Appendix I Evaluation of Montecito Association's Proposal

The draft environmental document was released in March 2012, and the comment period closed July 9, 2012. Although a comment letter was received from the Montecito Association within the allotted timeframe, the Montecito Association also submitted a proposal of two concepts for the Cabrillo Boulevard/Hot Springs Road Interchange in November 2012 and March 2013. To address the proposed concepts, Caltrans staff gave a Plan Evaluation and Findings PowerPoint presentation to the Santa Barbara County Association of Governments board on May 16, 2013.

Figure 2 shows Concept 1

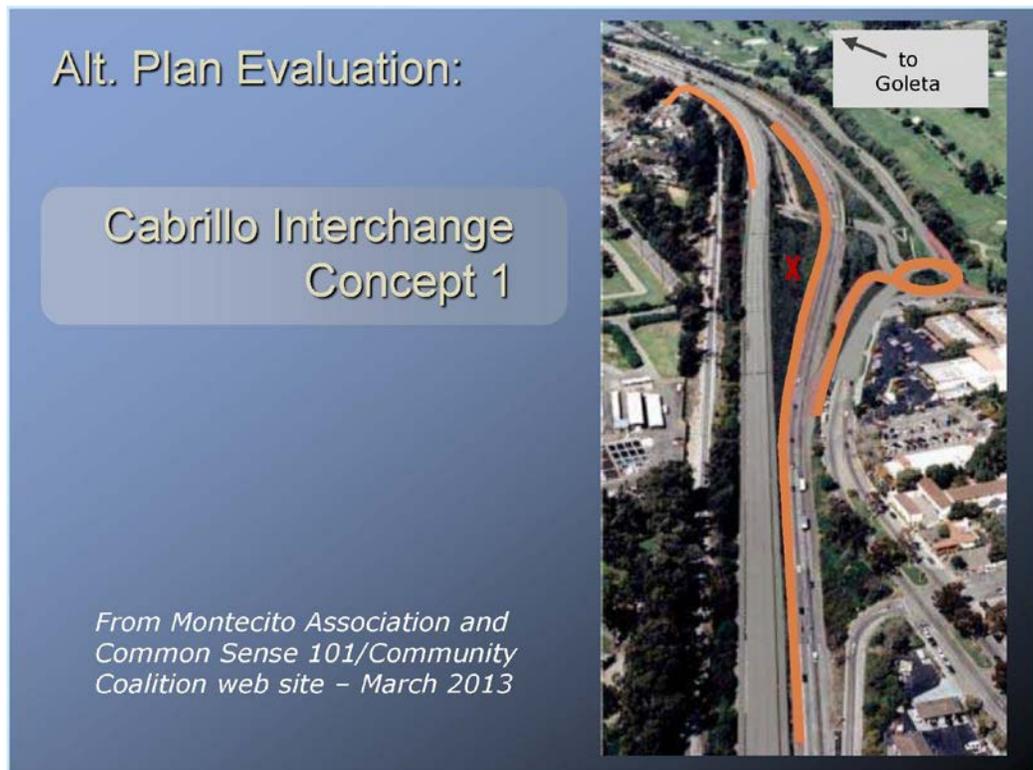
Concept 1 involves the roundabout, which required an additional iterative design and operational analysis. The conclusions of this analysis were as follows:

- The roundabout configuration shown above would result in unacceptable operations as the new off-ramp would queue or cause a backup of vehicles onto the mainline.
- This concept would require a larger roundabout configuration that provides increased spacing between entry points (refer to figure on next page).
- A larger roundabout that provides for adequate operations would result in extensive right-of-way impacts to the golf course and/or shopping center.

Caltrans' Findings for Cabrillo Interchange Concept 1

- Acquisition of private and commercial property would be required to reconstruct the roundabout.
- Union Pacific Railroad will not permit modifications at Los Patos as proposed by Montecito Association.
- Concept 1 would not result in cost savings.
- Left-side ramps cannot be retained due to safety and operational reasons (refer to Fact Sheet for left-side ramps in Appendix J)

Figure 14 shows the Montecito Association's proposal for Concept 2

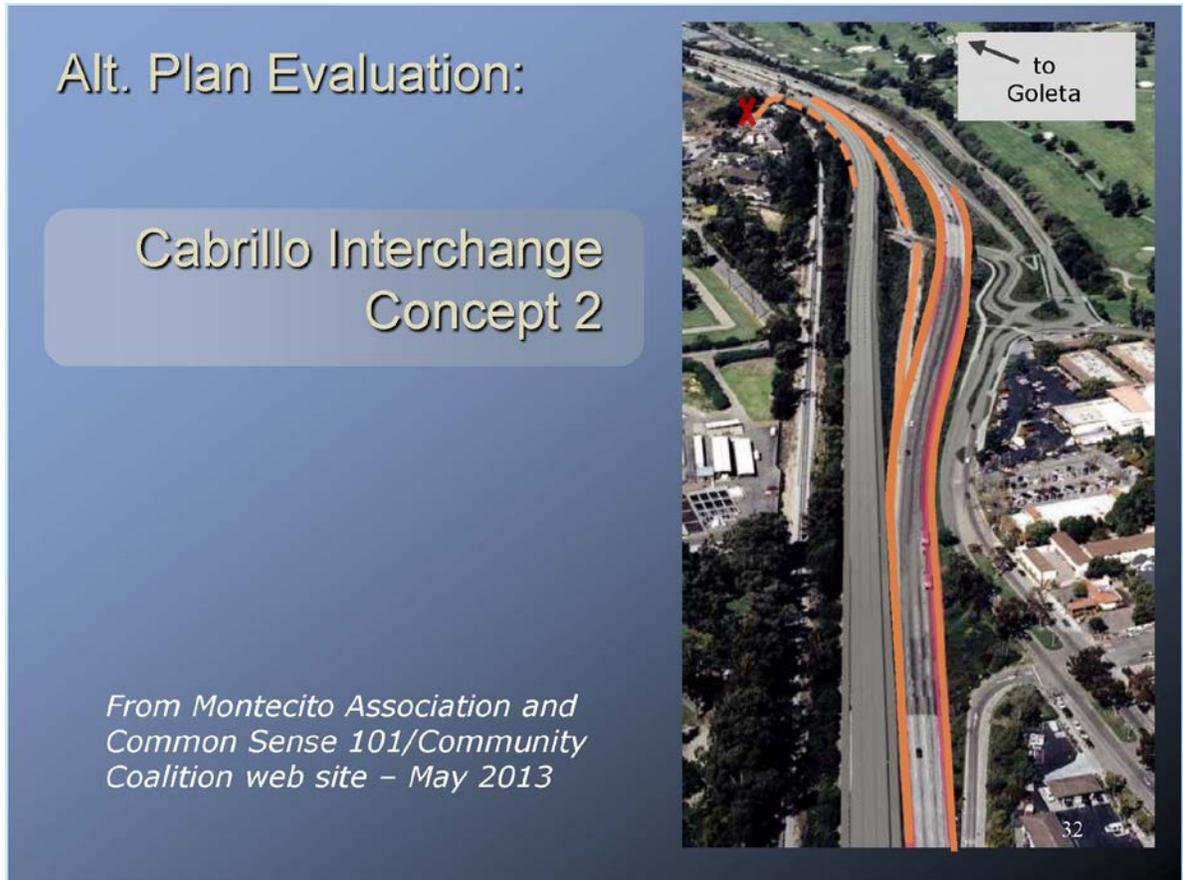
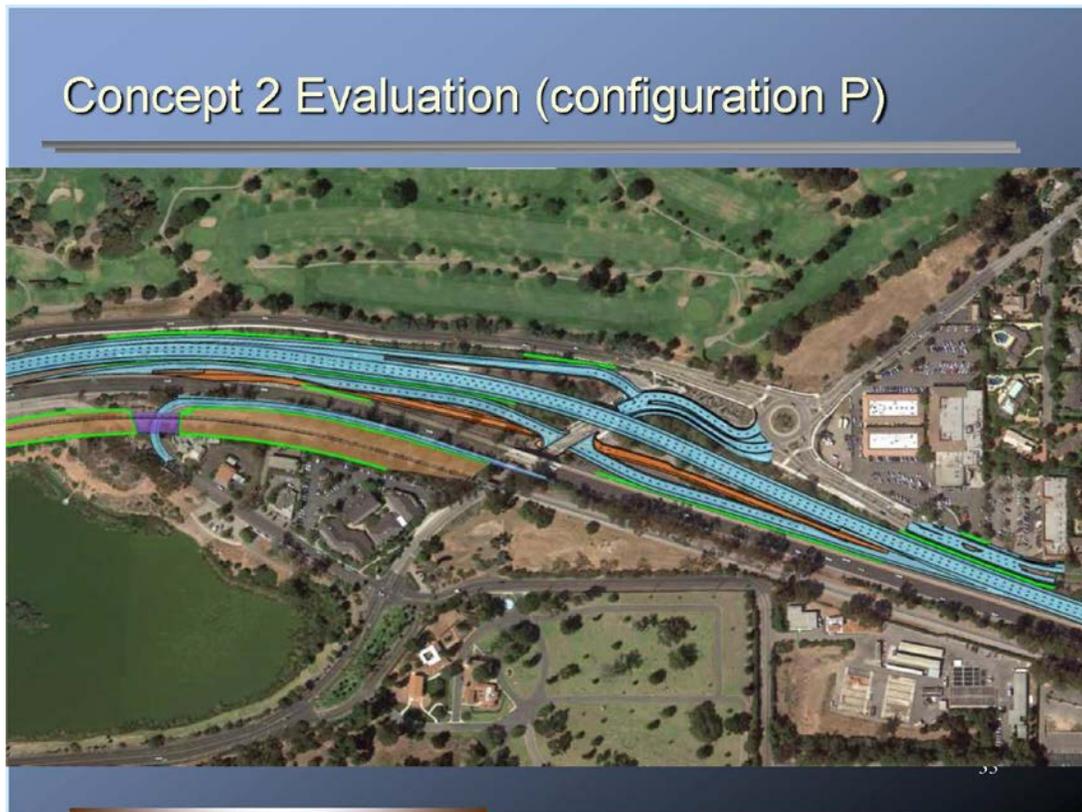
This proposal is effectively the same as configuration P previously considered by the Project Development Team shown in Figure 15

Caltrans' Findings for Cabrillo Interchange Concept 2

- Concept 2 requires reconstruction of existing ramps.
- Concept 2 requires partial reconstruction of Coast Village Road.
- The order of magnitude costs: \$27 million.
- Adding a future southbound on-ramp would require railroad reconstruction and an on-ramp at Los Patos (+\$21 million = \$48 million).
- Left-side ramp user expectation, weave, and diverge issues remain.
- Total estimated construction duration would be approximately 28 months.

Figure 19 shows the layout required to retain the median planter

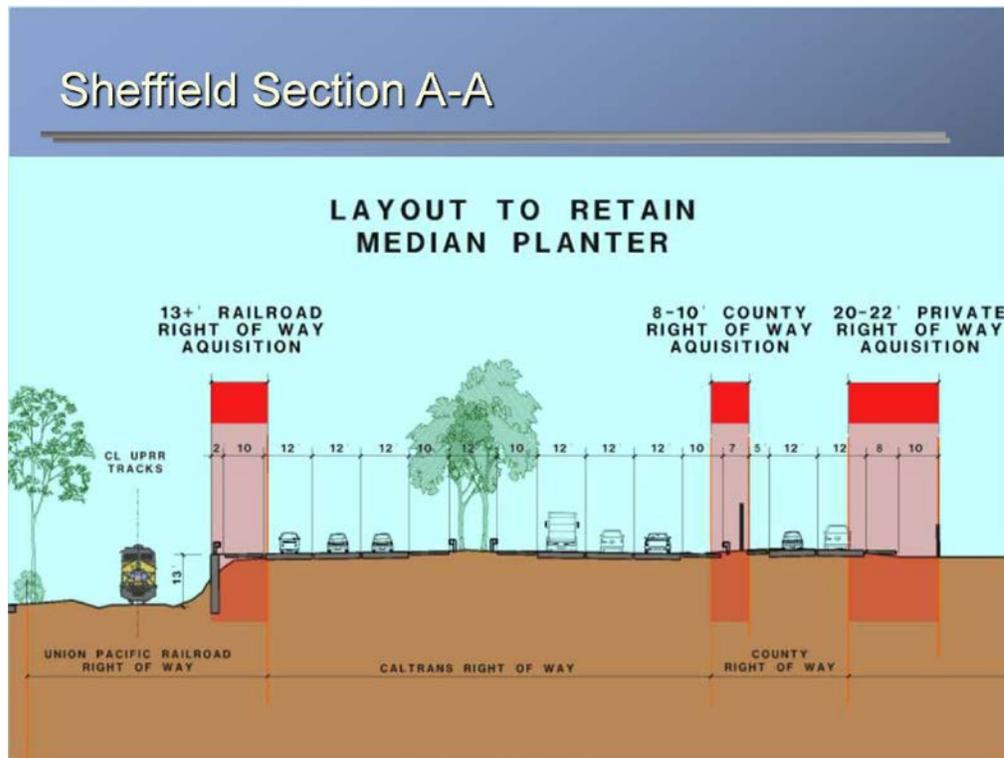
- Acquisition of property from Union Pacific Railroad is required.
- Median landscaping cannot be maintained without acquisition of private residential properties along North Jameson.
- Left-side ramps cannot be retained due to safety and operational reasons.

Southbound Ramp Conditions:

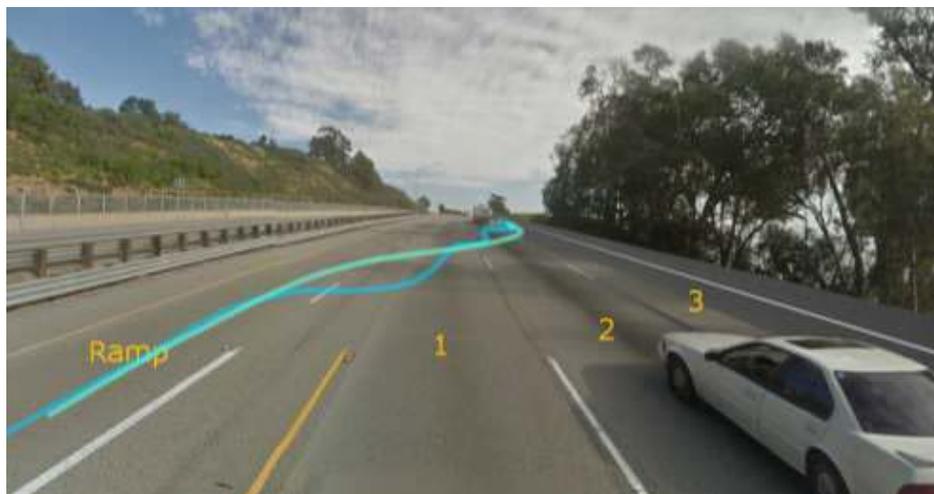
- The existing southbound on-ramp enters from below the freeway on uphill grade into the fast lane.
- Spacing to Evans off-ramp - there is limited area for weaving between successive ramps.
- Left-side ramps - Added lane would exacerbate operational and safety issues.

Caltrans Findings for the Montecito Association Concept for the Sheffield Interchange
